I-5/SR 161/SR 18 Interchange Improvements – Stage 2 Value Engineering/Practical Design Workshop

Final – Report

Prepared for
Washington State Department of Transportation

Prepared By:
HDR, Inc.

Figure 14 – VE/PD Ramp

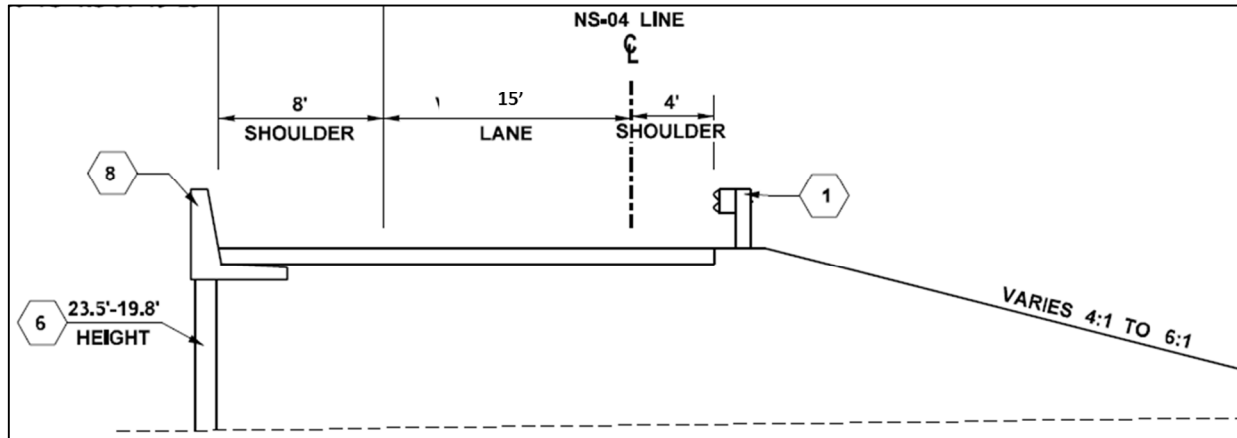
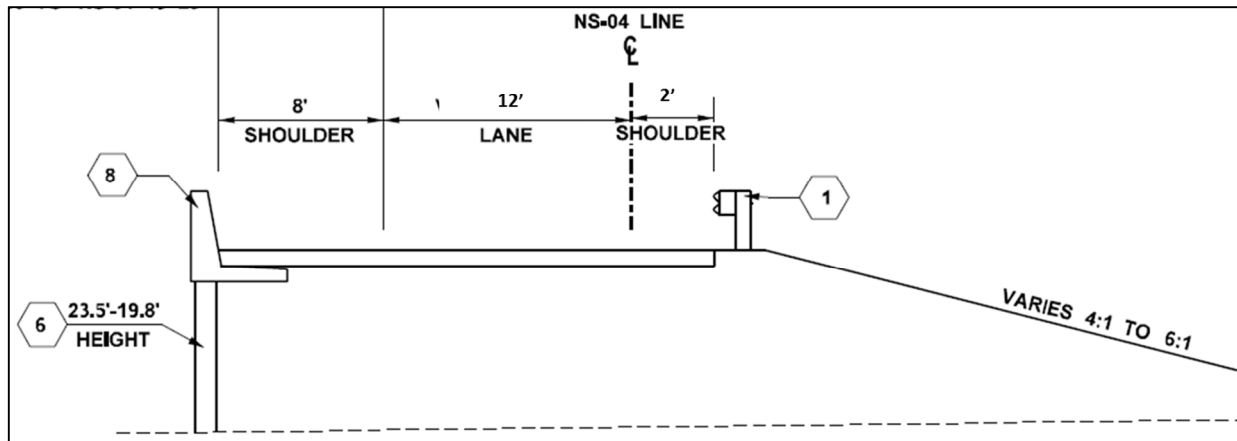
The VE/PD recommendation is to reduce the 4' shoulder to 2' and the lane width from 15' to 12'.

Utilizing this configuration for the length of the ramp will reduce construction costs through a reduction in paving quantities, embankment and bridge costs.

Figure 16 – Portion of WSDOT Standard Plan C-2k

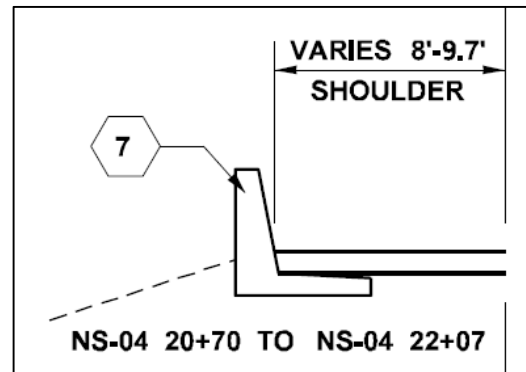
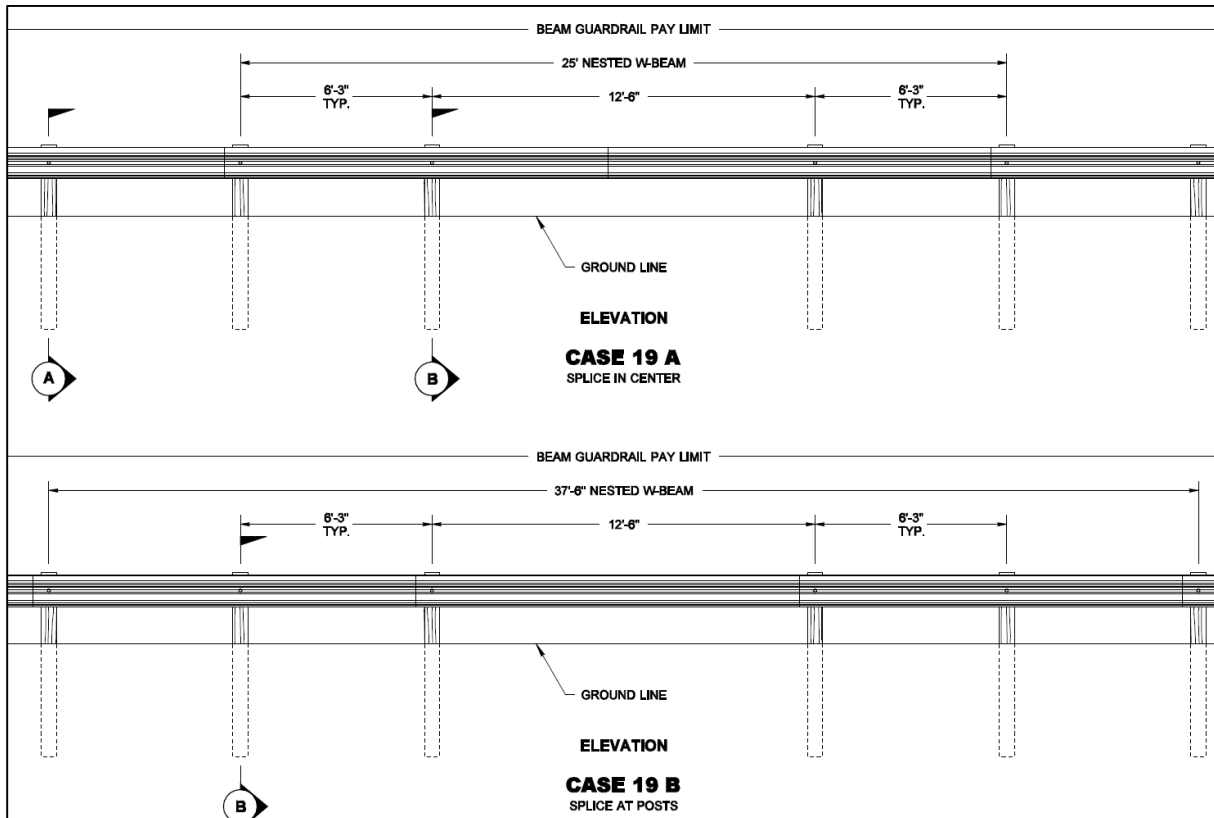
The baseline condition includes construction of a concrete barrier mounted to a concrete moment slab. The purpose of this concrete barrier is to prevent errant vehicles from going down a steep slope at the headwall of a small (approx. 48") culvert. The purpose of the moment slab is to provide a large enough anchor to prevent the concrete barrier from rotating backwards if struck by an errant vehicle.

The VE Recommendation is to use nested guardrail (multiple layers of metal railing) as shown in WSDOT standard plan sheet C-2k.

Figure 17 – Signal Locations

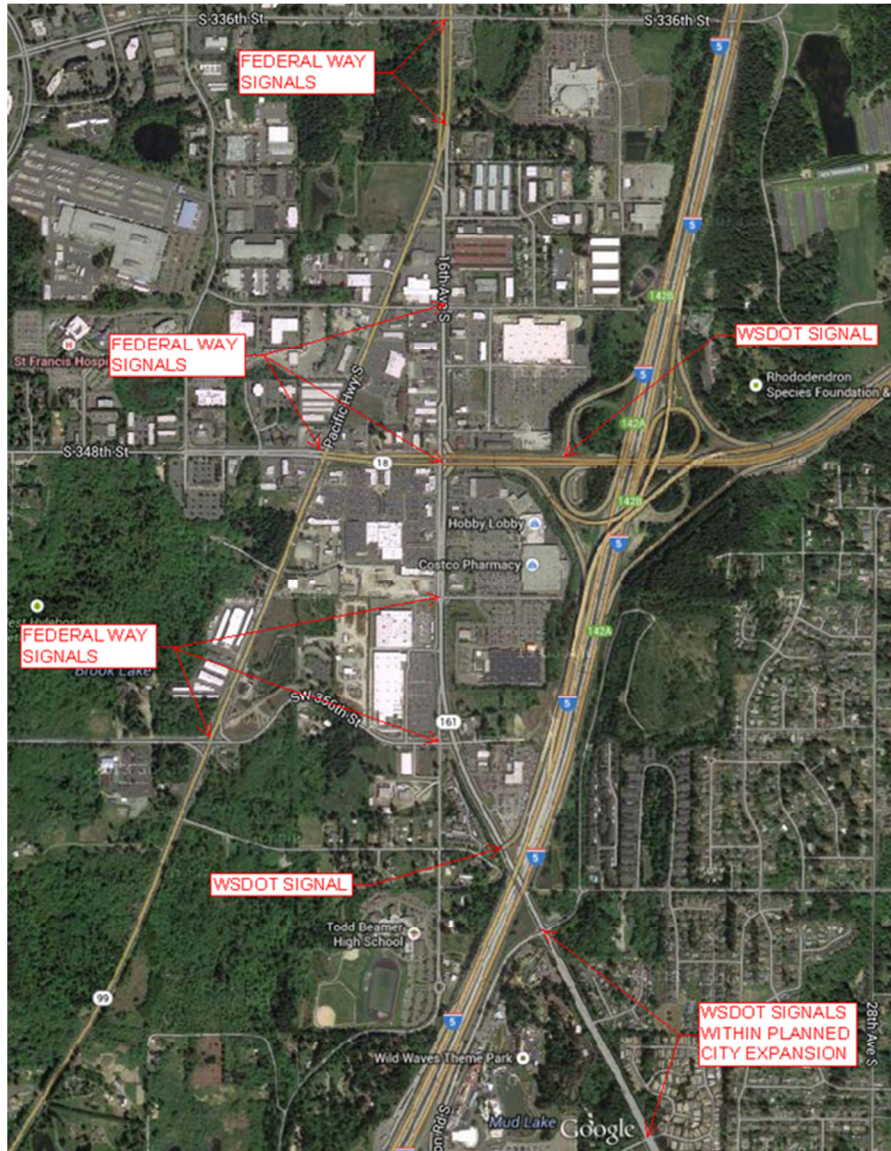
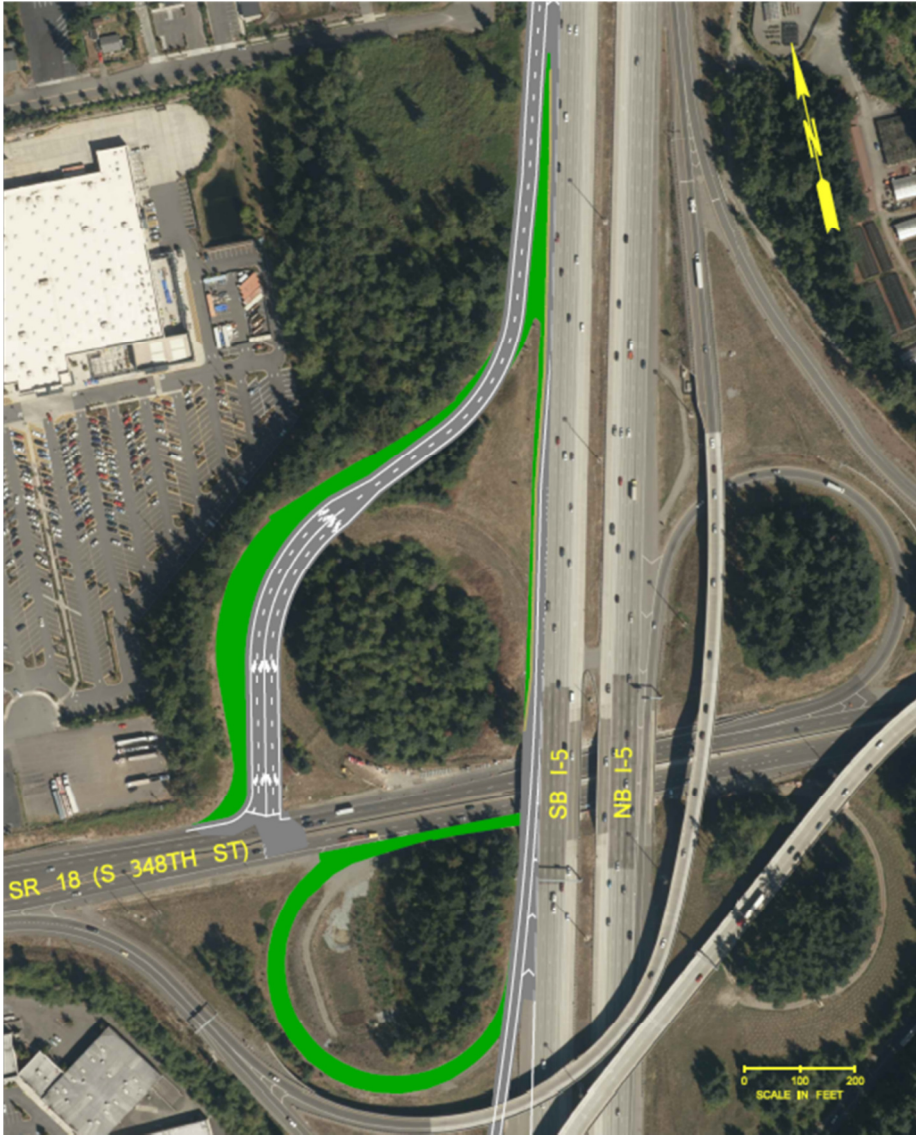
Improve signal coordination by having one agency control all signal timing consistent with the rest of the local agency. This will decrease delay and queue lengths. It should also minimize vehicle conflicts particularly rear end collisions.

Currently WSDOT controls all signals at ramp terminals. The controllers are different than what the City of Federal Way uses and the software is incompatible too. Although coordination is feasible it is essentially time-based coordination because the different systems are not synchronized consistently. WSDOT response to public concerns may vary in addition to translating timing data between controller software.

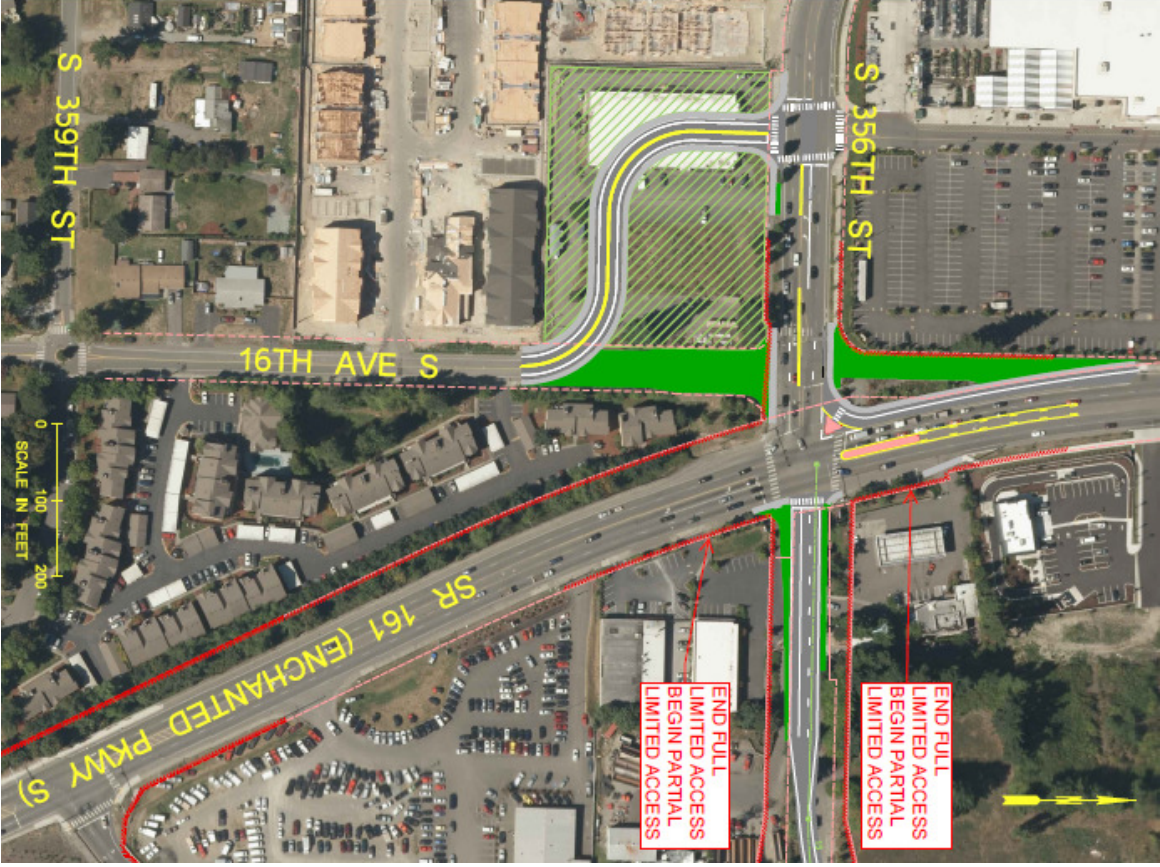
<p>This option reduces commercial impacts to the community at no cost to WSDOT and should reduce right of way costs.</p>

<p align="center">Figure 21 – VE/PD Access Control</p>	
<p>If VE/PD Recommendation 7 is accepted this recommendation would not be needed.</p>	
<p>Assumptions/Calculations</p>	
<p>Purchasing modified limited access is less expensive than total acquisition of property. Modified limited access will allow current business access on SR 161 to remain in place. The total right-of-way acquisition cost from the provided estimate for 4 properties is \$9.60 million. With no breakdown provided to determine the cost of each individual property it is assumed that the Paint Store and the Auto Shop are \$4.80 million of this estimate. Assume that if access is purchased it would be approximately 15% of the total cost or \$0.72 million for a \$4.08 million savings.</p>

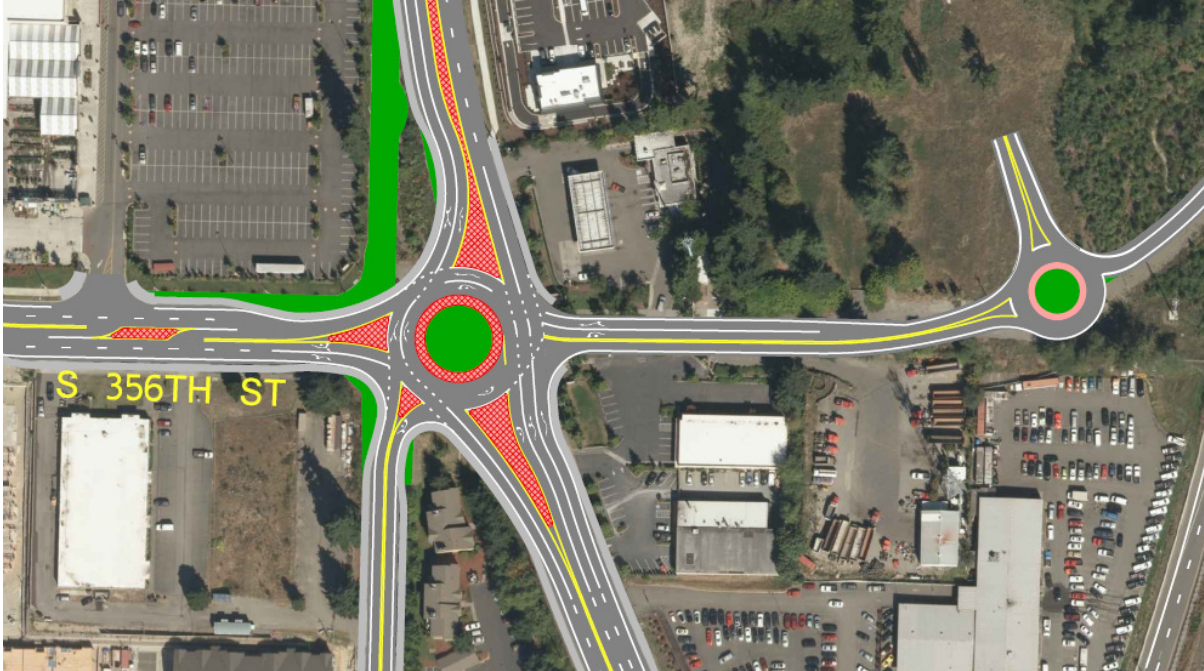
<p>Recommendation No. 7 New Ramp Terminal</p>	<p>IDEA NO. C-32</p>
<p>Comments/Justification</p>	
<p>If this is a Design Build project, efficiencies will be realized in a bigger design effort that involves I-5 ramps, etc.</p> <p>Based on a ramp terminal roundabout example in Thurston County on size and placement and serving as a transition roundabout from a higher speed to lower speed facility, an ICD would be in the 100 to 125' range and serve the design vehicle and business property to the north.</p>

<p>Figure 22 – VE/PD Relocated Ramp Terminal</p>	
<p>Shifting the ramp terminal will allow the limited access to terminate east of SR 161, and may eliminate a large portion of the property acquisition along SR 161.</p> <p>The roundabout for the ramp terminal can be constructed on the existing WSDOT right-of-way acquired during Stage 1 of this project.</p>	
<p>Assumptions/Calculations</p>	
<p>Based upon previously constructed one lane roundabouts with no right-of-way acquisition, the estimated construction cost of this roundabout is \$0.80 million.</p>	
<p>The costs for the reconstructed portion of 356th between SR 161 and the new ramp terminal are already included in the provided estimate.</p>	
<p>The right-of-way needed at the intersection of the baseline ramp terminal is \$9.60 million. The VE/PD recommended ramp terminal would not require and right-of-way only the purchase of some access control. Assume 15% of the cost of the baseline right-of-way need or \$1.44 million.</p>
